AMENDMENTS TO THE DRAWINGS:

REMARKS

Appendix A

(Marked Up Sheets For Figures 1-3)

Fig. 1

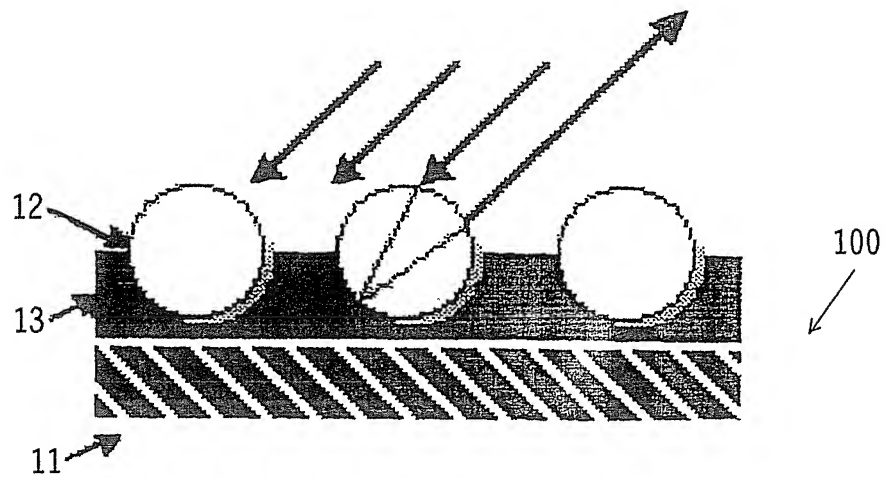
The examiner objected to Figures 1-3 because they do not include the legend "Prior Art"

ADD DESIGNATION

(PRIOR ART)

Fig. 2

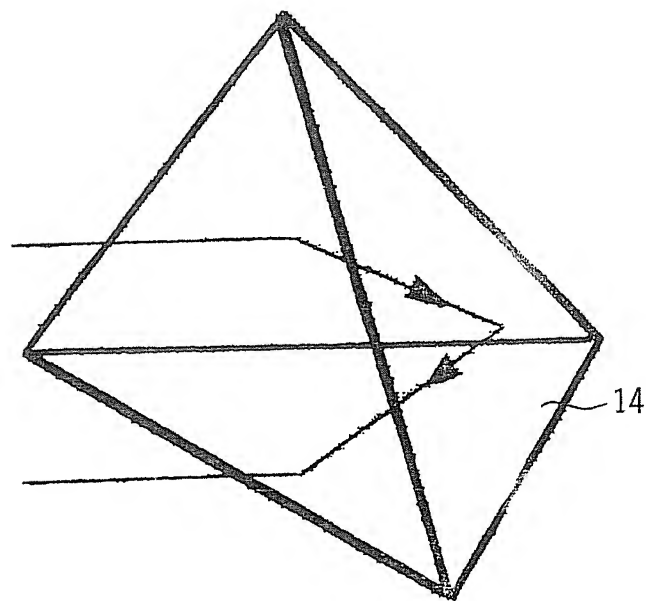
ADD DESIGNATION

(Prior Art)

Fig.3

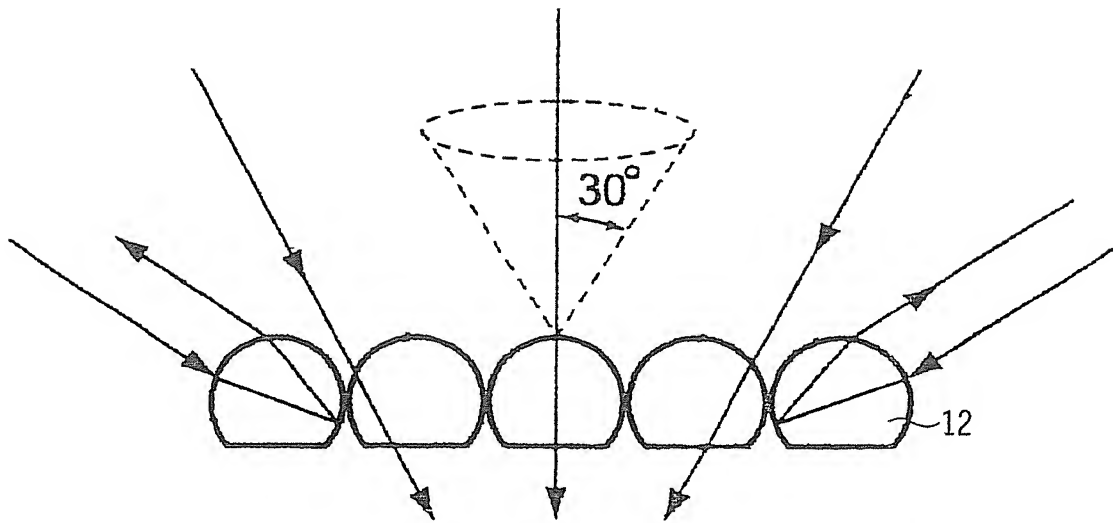
ADD
DESIGNATION

(Prion Art)
